# PROPOSED STAGE 3 SOLAR ENERGY SYSTEM INCLUDING SUBDIVISION GUNNEDAH, NSW

## IRONBARK ENERGY PTY LTD

## **RESPONSE TO REQUEST FOR ADDITIONAL INFORMATION – DA 2023/26**

**Table 1 – Response to Additional Information Requested**

DRAWING  
**PROPOSED FENCING PLAN**

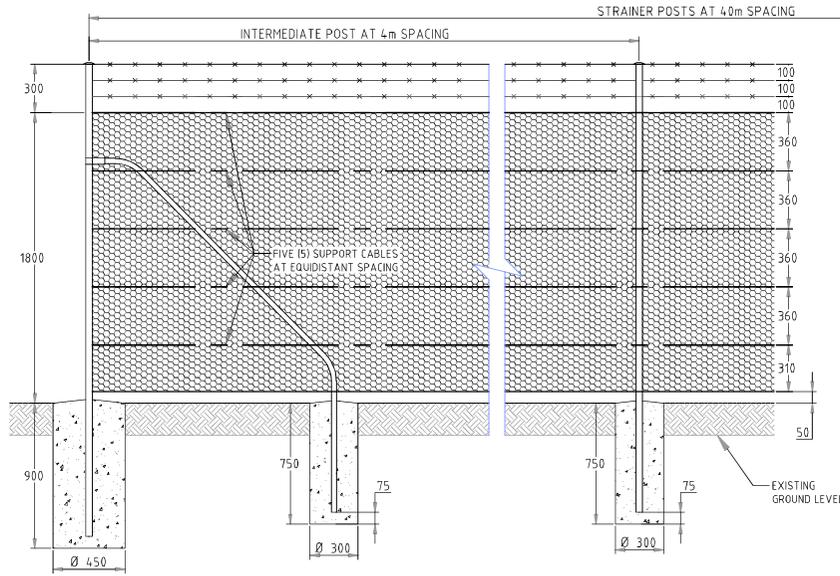
Additional Information Requested	Comments
	<ul style="list-style-type: none"> <li>Given the nature of solar tracking, noise generated from the solar panels is expected to be extremely intermittent given the small amount of movement required to track the sun over the period of a day.</li> </ul> <p>Given the existing assessment and list of mitigation measures provided in the SEE, no significant operational noise and vibration impacts are expected to occur during the operation of the proposed development.</p> <p>In respect of Council's comment, no addendum to the existing SEE is considered necessary.</p>
<p>4. Council acknowledges the inclusion of the Substation as part of this development application for further assessment. However, additional information is required in the form of section and elevation plans; including, but not limited to, heights of earth mounds and heights of the transformers and plants contained within proposed substation area. Additionally, provide confirmation on how the substation area would be accessed?</p>	<p>Detailed design and procurement of project components has not yet occurred and therefore specific details of the proposed arrangement is not available. It is however noted that the substation proposed has been approved by Council twice previously on the basis of the same information provided, and is only reflected via this DA to ensure that the substation can be provided regardless of which solar farm is built first.</p> <p>As detailed via drawing 01B_TP07 the substation will be accessed via a lockable gate at the intersection with a perimeter access road. The perimeter access road will extend north of the substation, along the 25 m wide right of way and through Lot 23 and Lot 22, connecting to the new driveway installed from Quia/Ross Road. A security gate will be installed at the entry to the solar plant along the northern boundary of Lot 22 as per drawing 01B_TP05.</p>

DRAWING  
**SUBSTATION GENERAL LAYOUT-BY OTHERS**

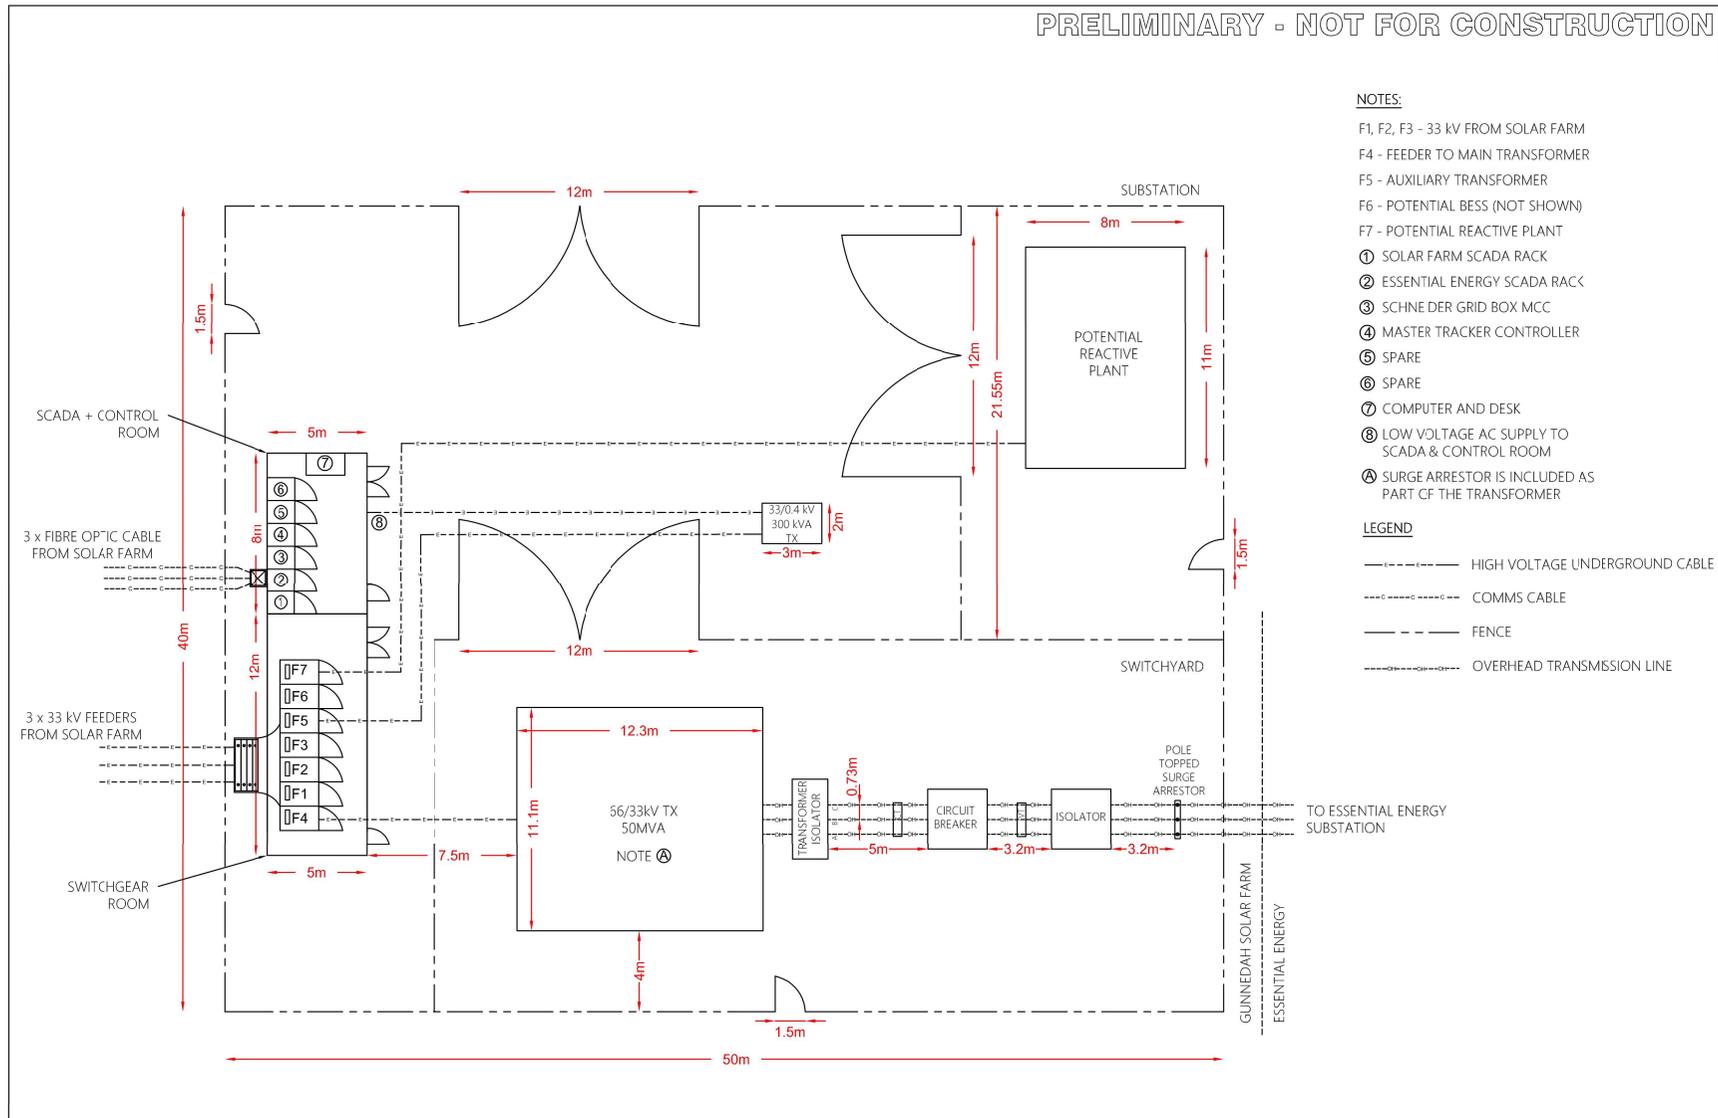
<p>4. <i>Development Application and Plans are to be updated to include the construction of the Electrical Substation as it is Council's understanding is that this structure is required for the operation of the proposed Solar Farm. Development plans are to be updated to include the location of the Substation and any Floor, Section and Elevation Plans for the proposed substation and amenities building(s) are to be submitted to Council, in accordance with Section 24 of the Environmental Planning and Assessment Regulations 2021;</i></p>	<p>The project drawings (<b>Attachment 2</b>) detail the location of the proposed Electrical Substation and Management Compound in relation to the proposed solar farm.</p> <p>The layout of the substation is provided within the existing Ekistica Drawings included in the drawing set as drawing 01B_TP10.</p>
<p>5. <i>Address Clause 6.5 Essential Services of the Gunnedah Local Environmental Plan 2012, with reference to the proposed Ablution Block and its requirement for Service connection such as Water and Sewer. Water and Sewer Services to be provided with DA2015/062, which have not been vested with Council, are not considered to be part of the public network and cannot be used for the servicing of the development</i></p>	<p>Section 4.5.1.6 of the SEE details that the proposed development has suitable vehicle access from the Southern side of Quia Road. No servicing connections with respect to the supply of water, the supply of electricity or the disposal and management of sewage is anticipated as a requirement for the project.</p> <p>As noted via the DCP compliance table in Appendix B of the SEE, in respect of clause 4.3 - Utilities and Services, the proposed solar farm does not generate a demand for water or sewer services.</p> <p>Notwithstanding the above, Premise acknowledge an inconsistency within Section 5.4 of the SEE which states "Service connections for the solar farm would be limited to water and sewer connections to service ablution facilities for one staff member</p>

PROJECT NUMBER: 221311 DRAWING NUMBER: 01D\_TP11 REV: D

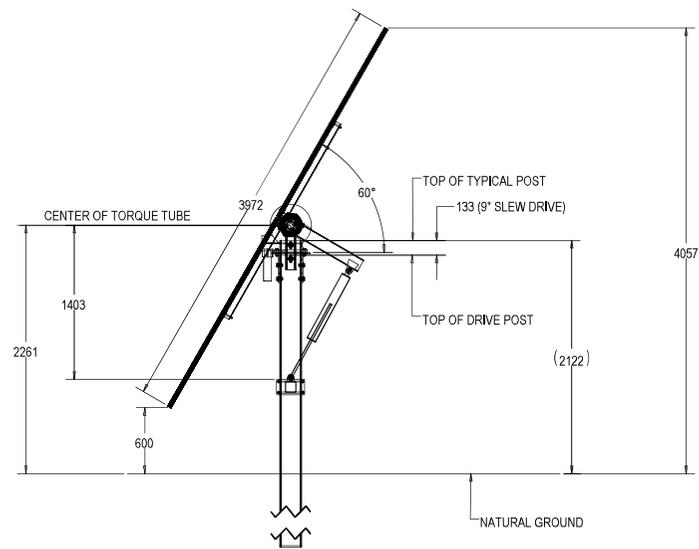
<p>10. <i>Further, can elevations of the solar panels be provided as the submitted development plans only contain the module layout?</i></p>	<p>See attached updated drawings (<b>Attachment 4</b>) providing indicative solar panel elevations.</p>
